## REMARKS

## ATTORNEY DOCKET NO.: 2002P00193US

First Named Inventor: Jeffrey A. Welton et al.

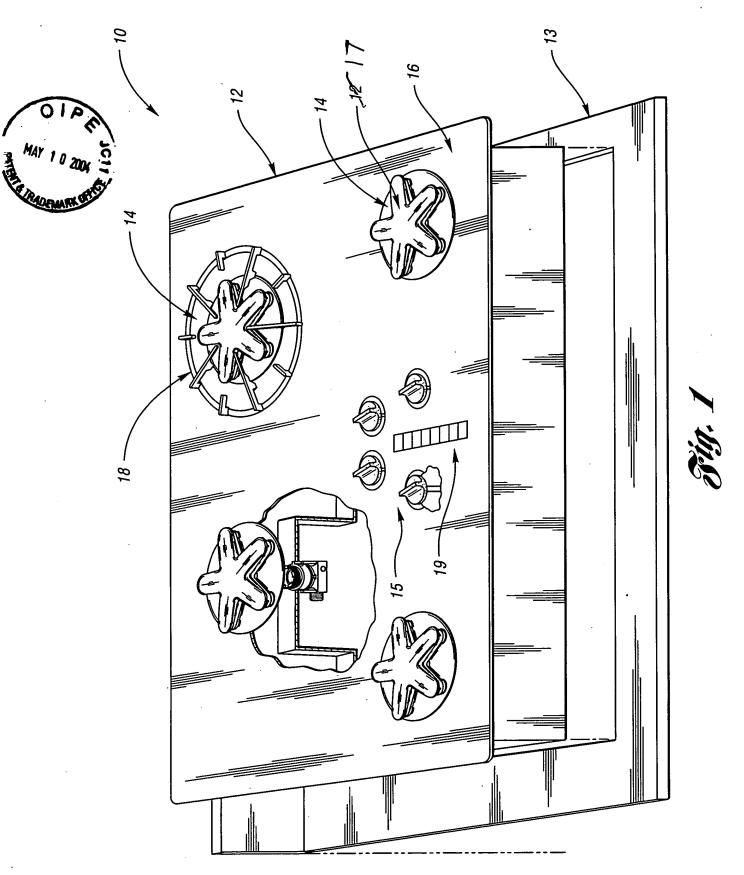
The Examiner objected to the drawings and the specification for failing to include reference characters associated with the "internal elements" which cooperate with the "indexer". These elements are the splines 38 on the stem 36 and the splines 78 inside the threaded sleeve 72, now properly illustrated on the amended drawings submitted herewith for the Examiner's approval. The elements are clearly illustrated interlocking in Figs. 6a and 6b. One minor correction is included to Fig. 1 to be consistent with the specification and the elements and minor corrections are also shown in corrections to Figs. 2 and 3. The attached amended drawings should clearly obviate the Examiner's objections to the specification and drawings.
